## ADDENDUM

NO. 1

**PROJECT NAME:** Lehman High School 2025 Additions and Renovations

**CLIENT NAME:** Hays CISD

## LEVEL 2 FRAMING PLAN - AREA B

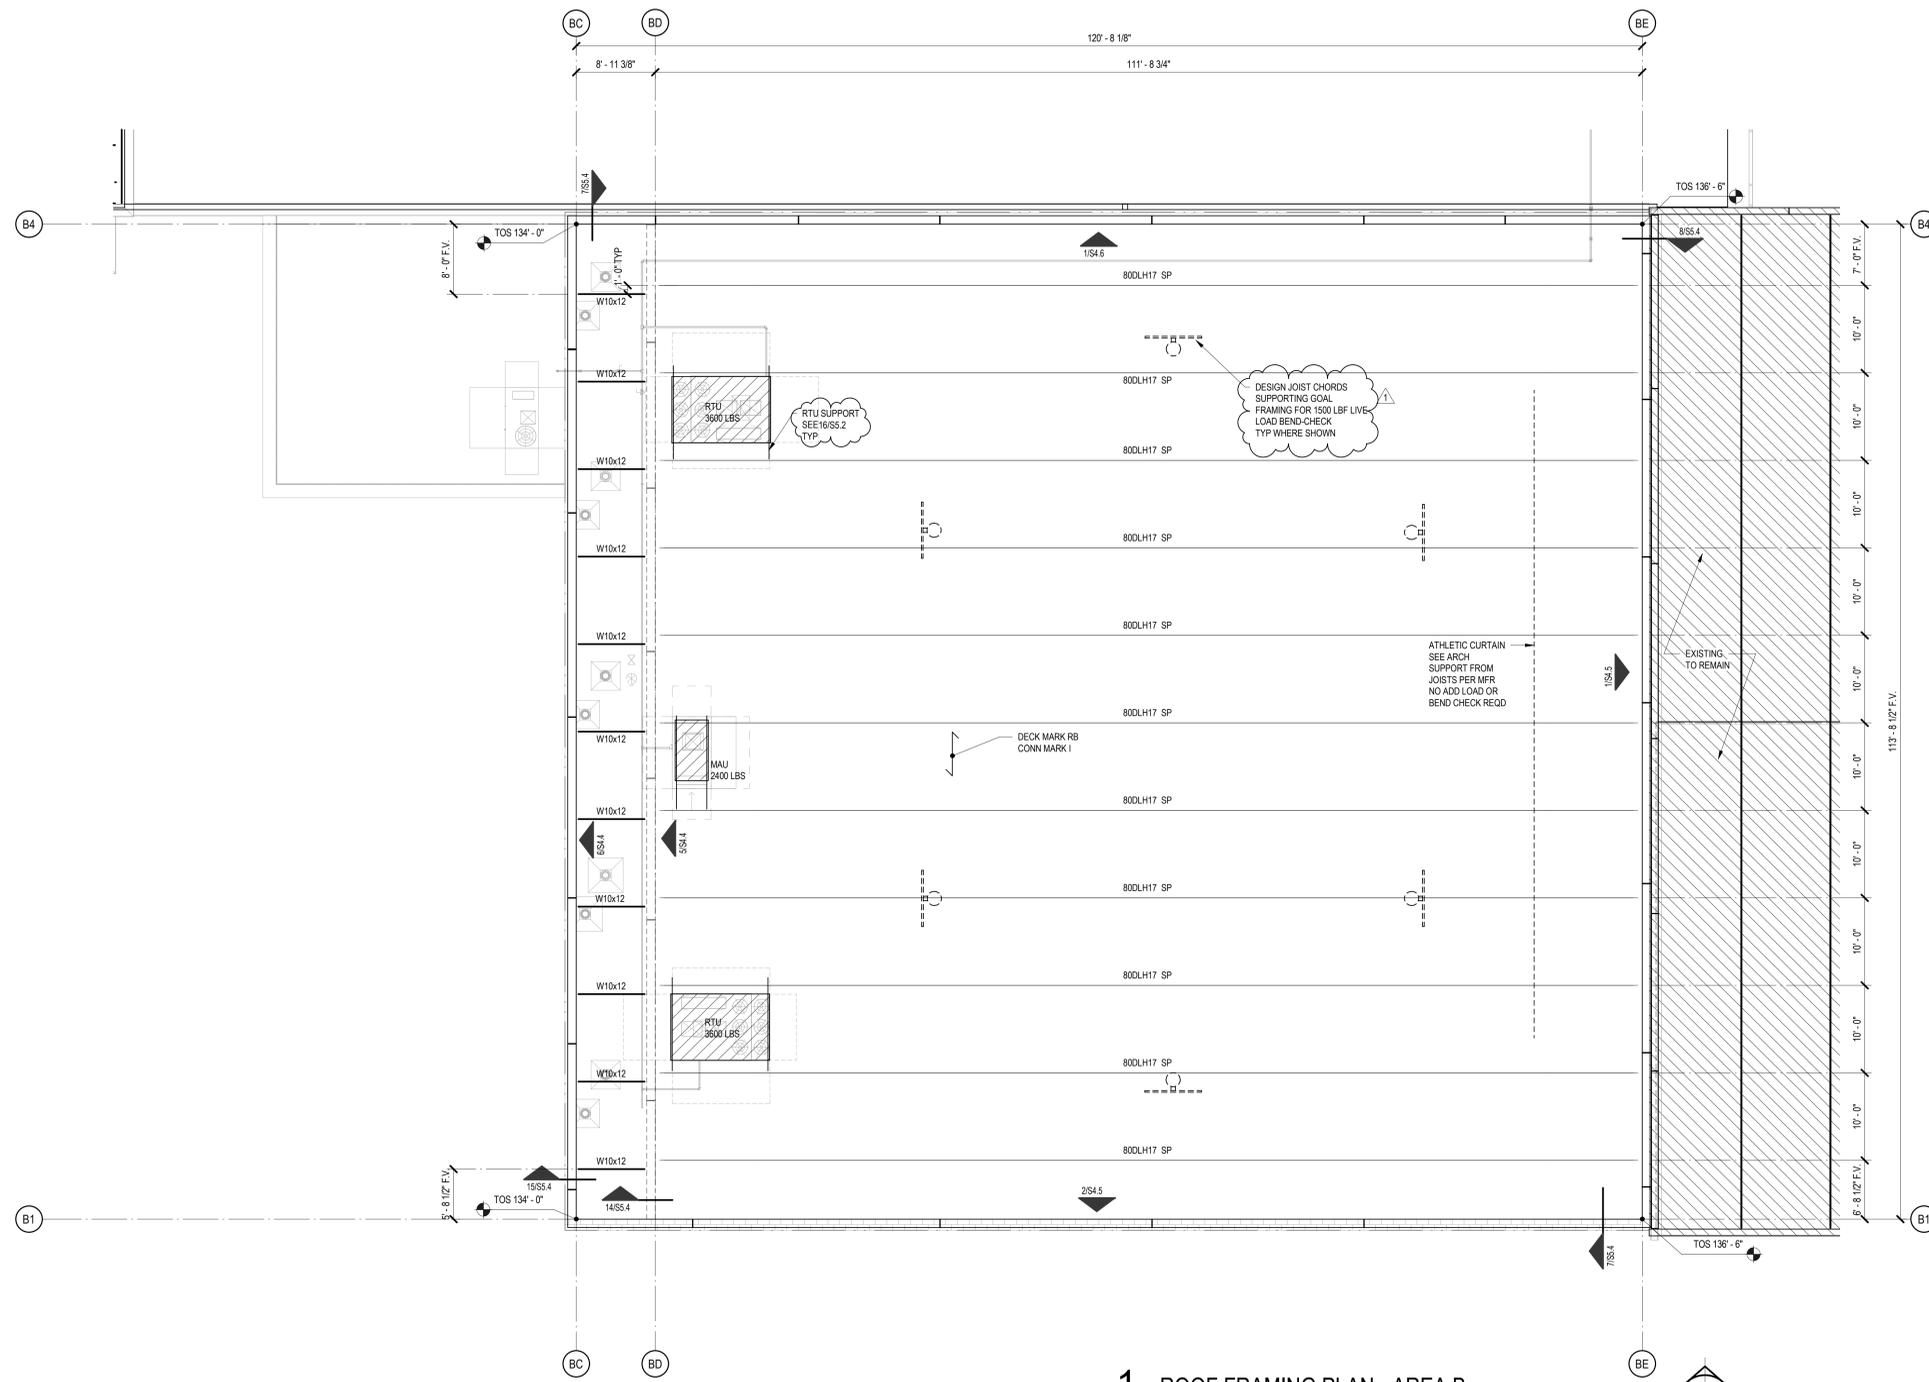
**AD No 1, Struct Item 5: To the Drawings, Sheet S2.1B2, "LEVEL 2 FRAMING PLAN - AREA B,"**

- 1) Updated detail reference where shown.

**FOUNDATION PLAN - AREA D**

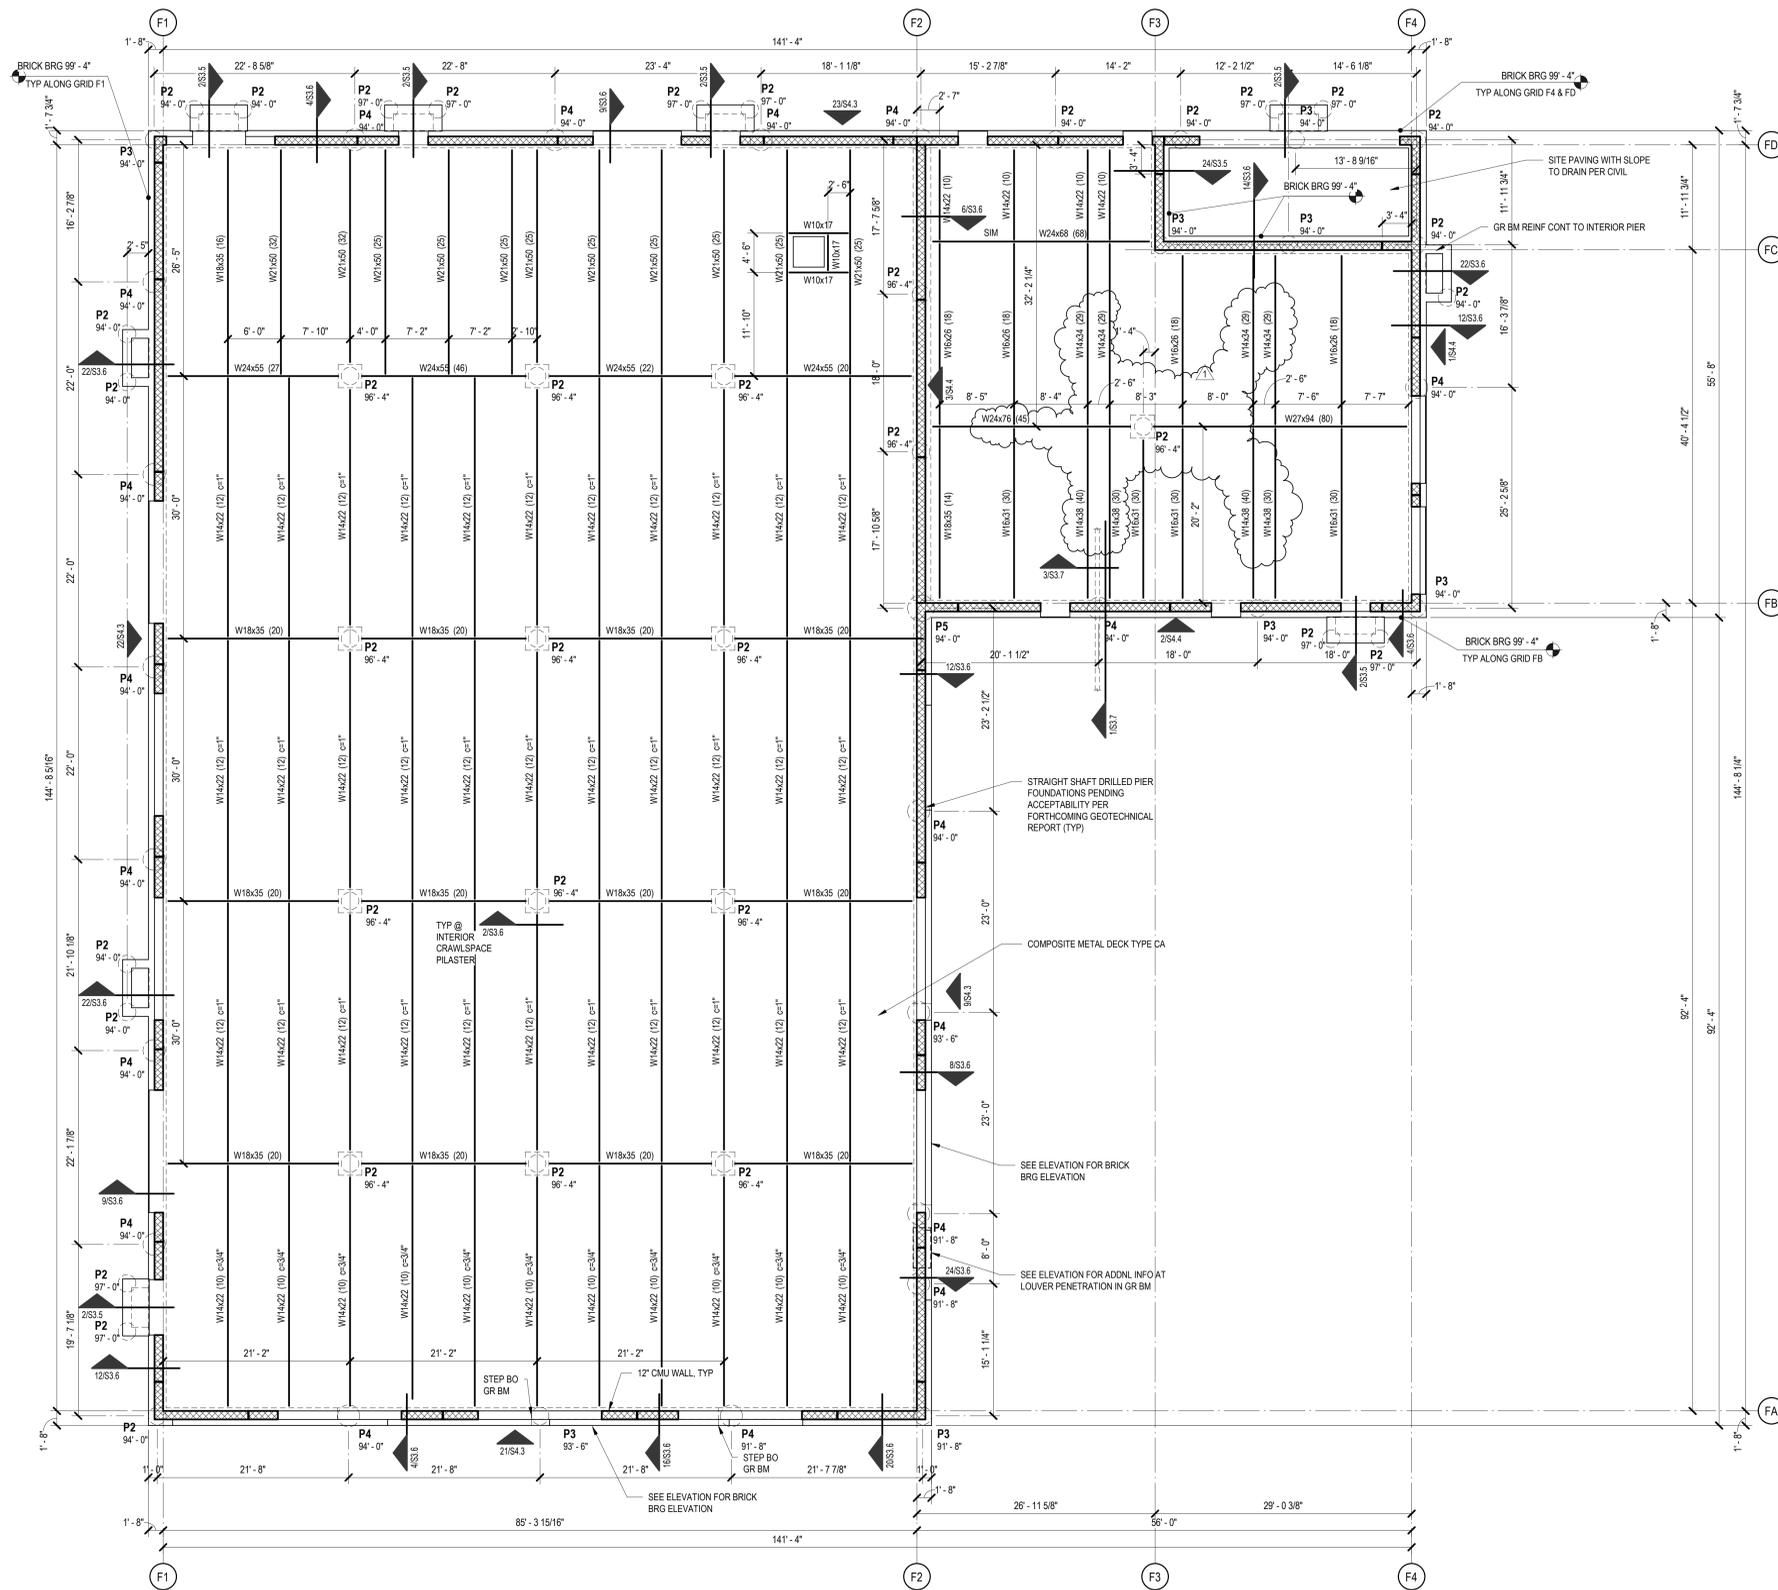
**AD No 1, Struct Item 9: To the Drawings, Sheet S2.1D1, "FOUNDATION PLAN - AREA D,"**

1 DEMOLITION PLAN, AREA D, LEVEL 1  
1/16" = 1'-0"

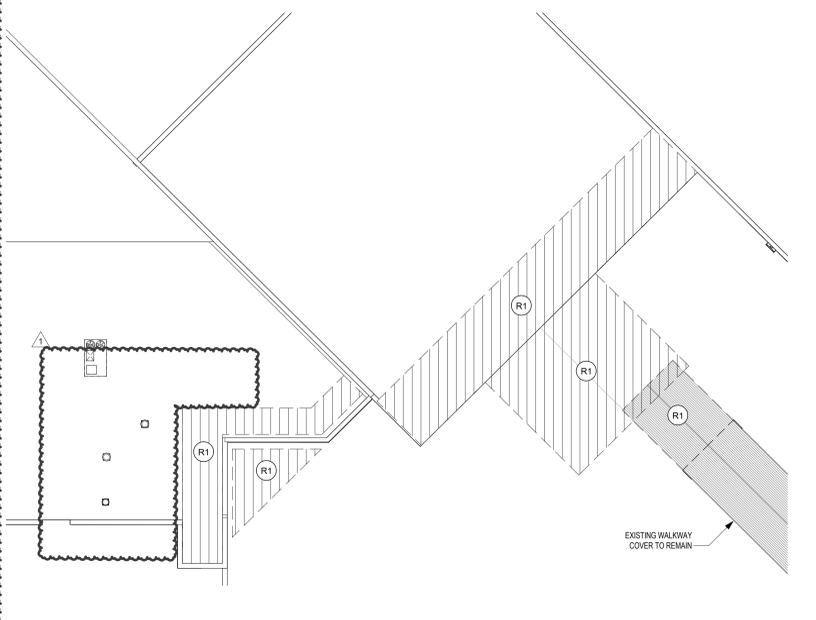
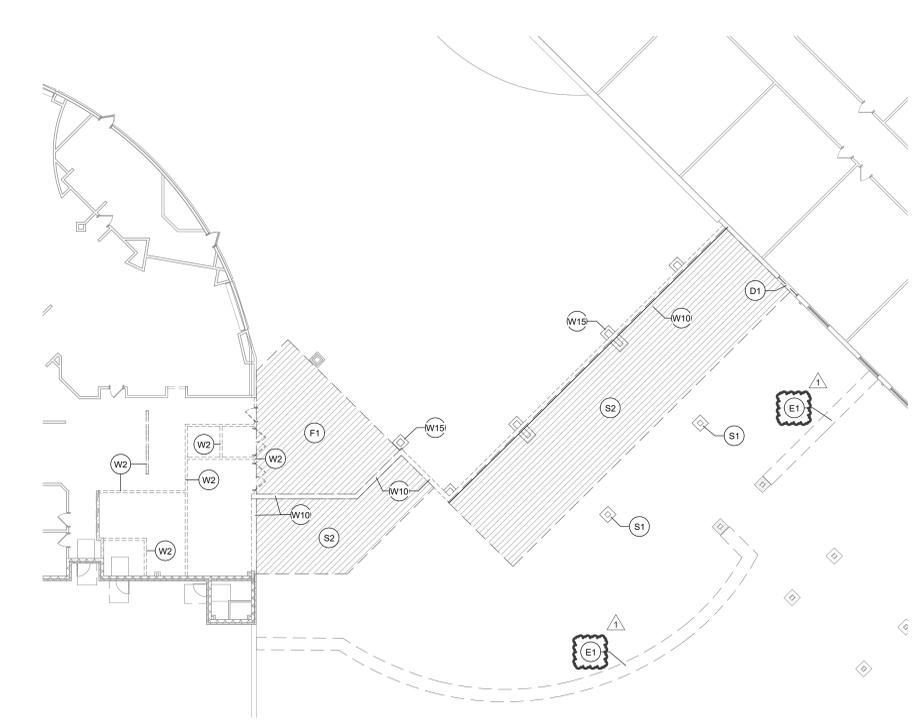
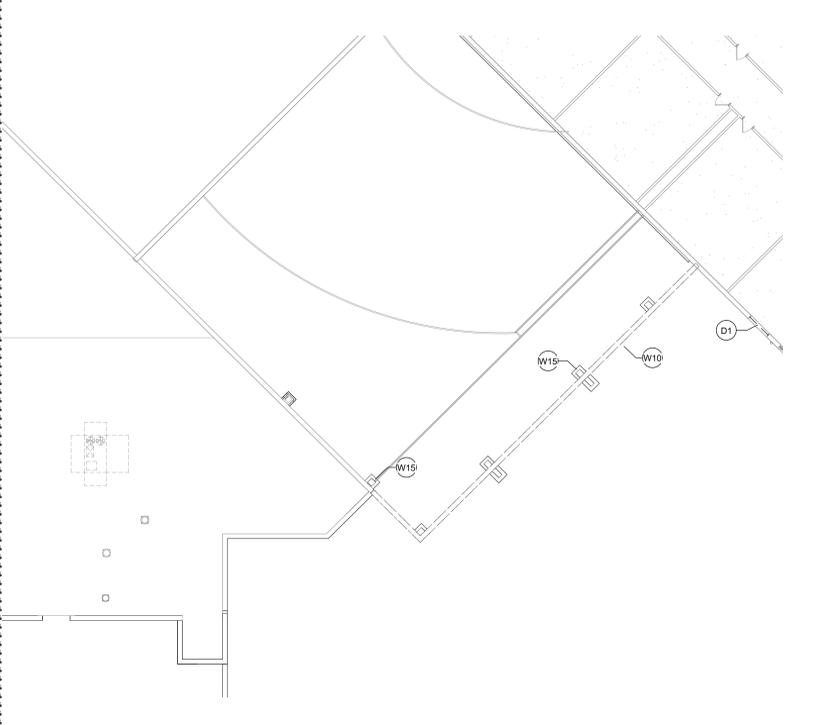
**AD. No 1, Arch. Item 8 To the Drawings, Sheet AD1.03 - "DEMOLITION FLOOR PLAN – AREA D,"**

- 1) Updated demolition scope and added more views for clarification

**FLOOR PLAN - AREA B - LEVEL 2**

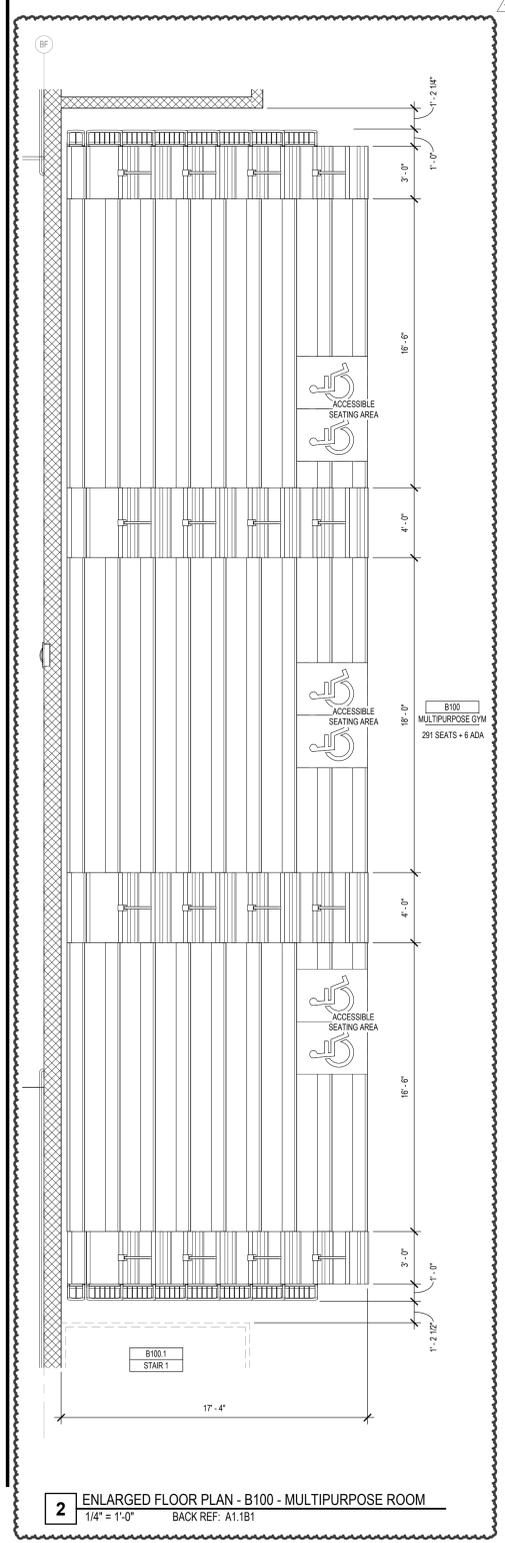
**AD. No 1, Arch. Item 11 To the Drawings, Sheet A1.1B2 - "FLOOR PLAN – AREA B – LEVEL 2,"**

- 1) Updated wall type tag for clarification
- 2) Updated opening to a door with card reader
- 3) Added wall section detail for clarification

**1** FINISH PLAN - AREA E  
1/8" = 1'-0"

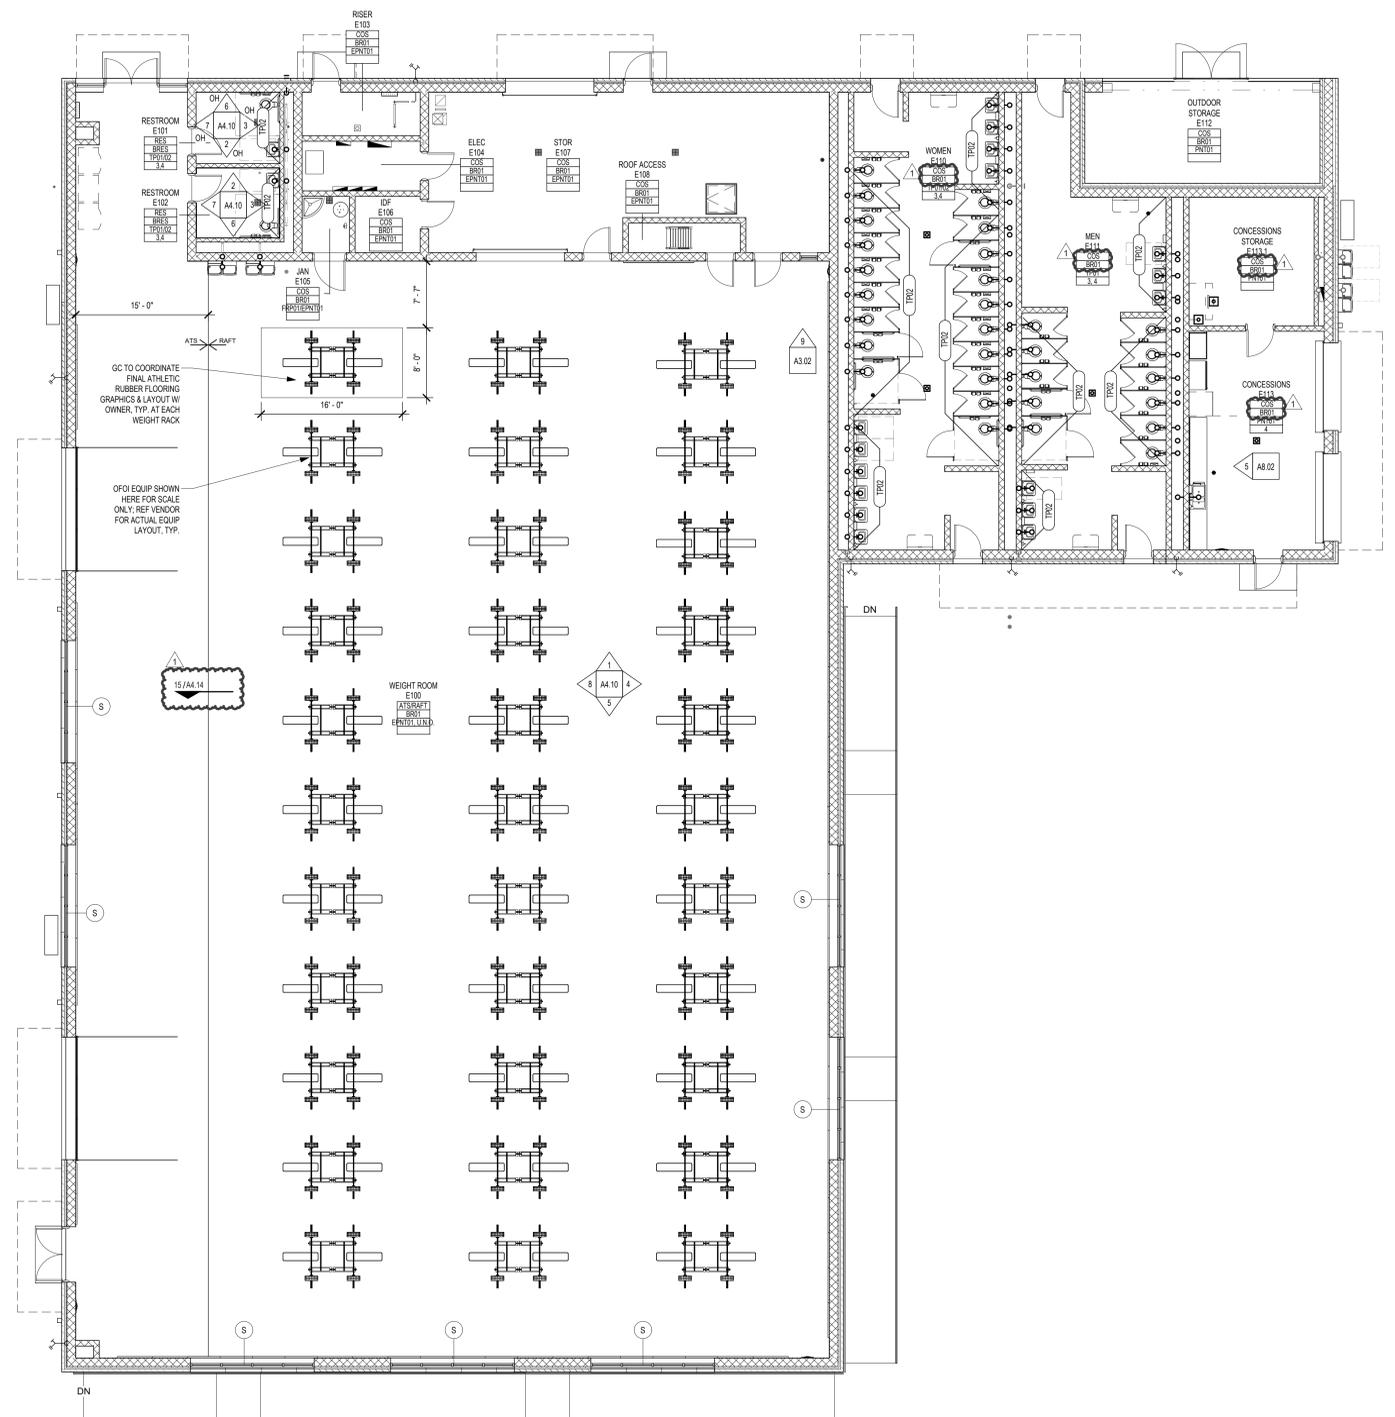
AD. No 1, Arch. Item 19 **To the Drawings, Sheet A4.1E1, “FINISH PLAN – AREA E”**

- 1.) Changed flooring material from resinous to sealed concrete in multiuser restrooms and concessions areas.
- 2.) Added Turf to Rubber transition detail in weight room area

5 EXTERIOR ELEVATION - AREA D - SOUTH WEST  
1/8" = 1'-0"

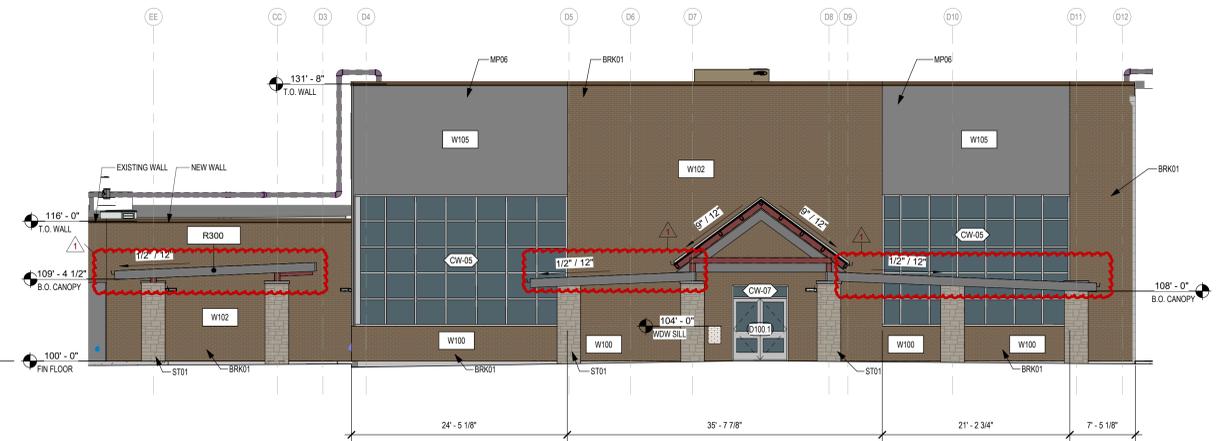
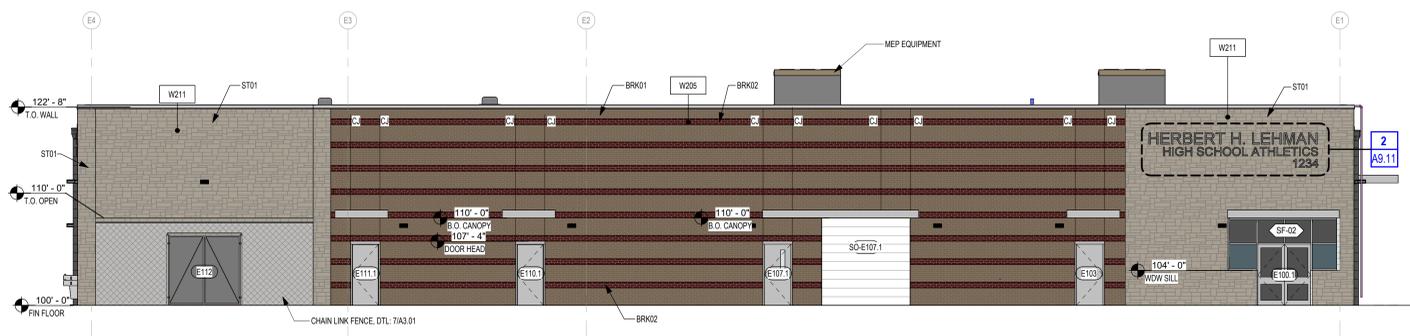
AD. No 1, Arch. Item 22 **To the Drawings, Sheet A5.03, “EXTERIOR ELEVATIONS - AREA D & E,”**

- 1) Changed grade line to reflect civil grade at 3/A5.03 & 6/A5.03
- 2) Added gutters and sloped canopy roofs at 2/A5.03
- 3) Cleaned up graphics to reflect proposed design at 5/A5.03
